Calga Sand Quarry MOD 3 - Additional Information

Figure 3.2
FRIABLE SANDSTONE RESOURCE

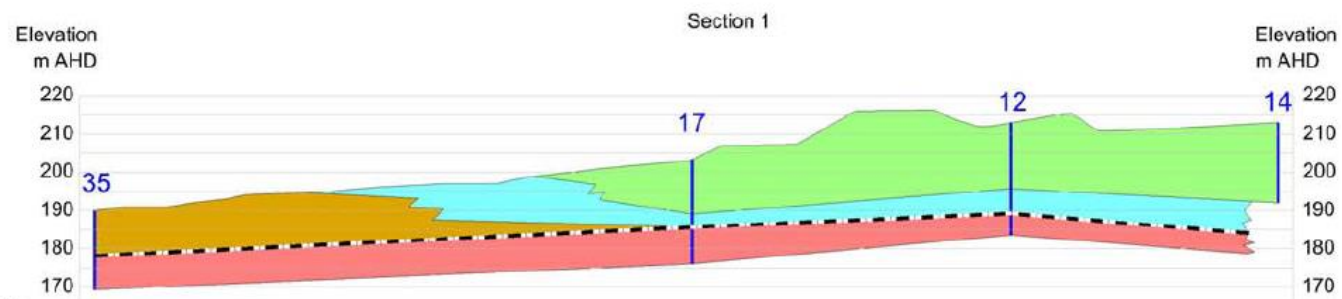
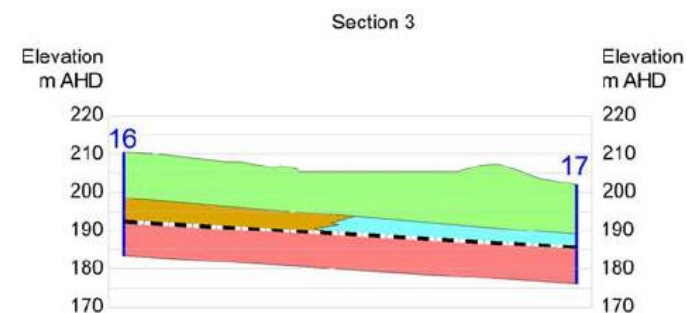
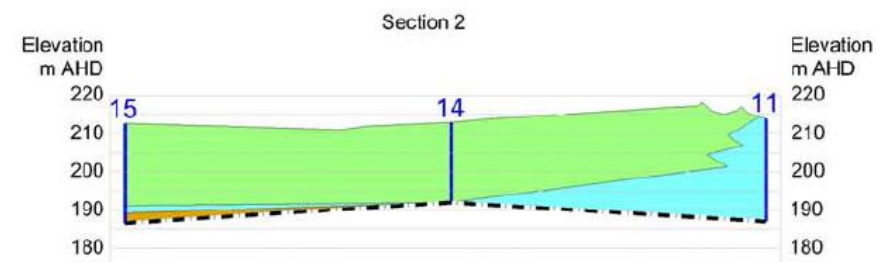
5. What assessments were carried out in relation to aquifer interference when the quarry was approved? Is there a depth below which quarrying is prohibited and if so how much deeper can quarrying go? Has this depth been determined in relation to the water table? If a depth limit has been established the Commission requests this limit be incorporated into a condition of consent to address community concerns.

In the 2004 EIS, an indicative depth of extraction ranging between 180-190m AHD was proposed by Rocla. This range reflected the availability of resource that could be extracted using the ripping methods proposed. The resource below these depths (Sandstone Unit 4) was considered unlikely to disaggregate into free sand grains. Thus, the extraction depth was determined by the depth of crushable ('friable') sandstone.

Rocla's drilling data indicated that the extraction depth would generally be between 180-190 m AHD (refer to Figures 3.2 and 3.3 below). Data from the 2004 EIS indicated a depth of the water table varying between 170 m AHD and 208 m AHD (an average depth of 195.9 m AHD). Thus, intersection of the groundwater table was predicted. The site's Water Management Plan predicts up to 49ML/year of groundwater inflows.

No specific AHD depth limit was proposed by the company in relation to Stage 3 nor was a condition of approval imposed for extraction depth. However, condition 2(b) of Schedule 2 of DA 94-4-2004, requires the company to carry out the development in accordance with the 2004 EIS (i.e. an indicative range of 180-190 m AHD).
